Service Bulletin No:	13-005
Group:	17 – Intake & Exhaust
Issue Date:	07-03-2013

SERVICE BULLETIN

SUBJECT:
**CORRECTION OF WORKSHOP MANUAL FOR 2011- 2013 CONVENTIONAL MODELS
(CORRECTION OF DPR FILTER AND DEF FILTER MAINTENANCE INTERVAL)**

EN10-26

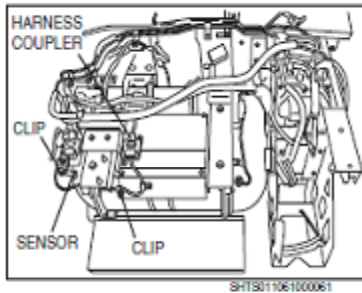
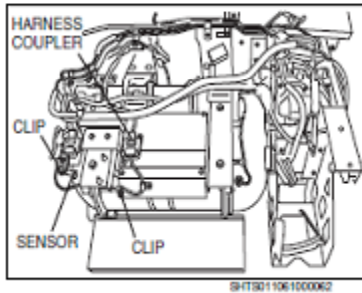
1) DEF filter element

Item	Content	Action	Travel distance
DEF filter element (& equalizing element)	Replacement	Replacement	60,000 mile

Wrong: 60,000 mile
Correct: 150,000 mile
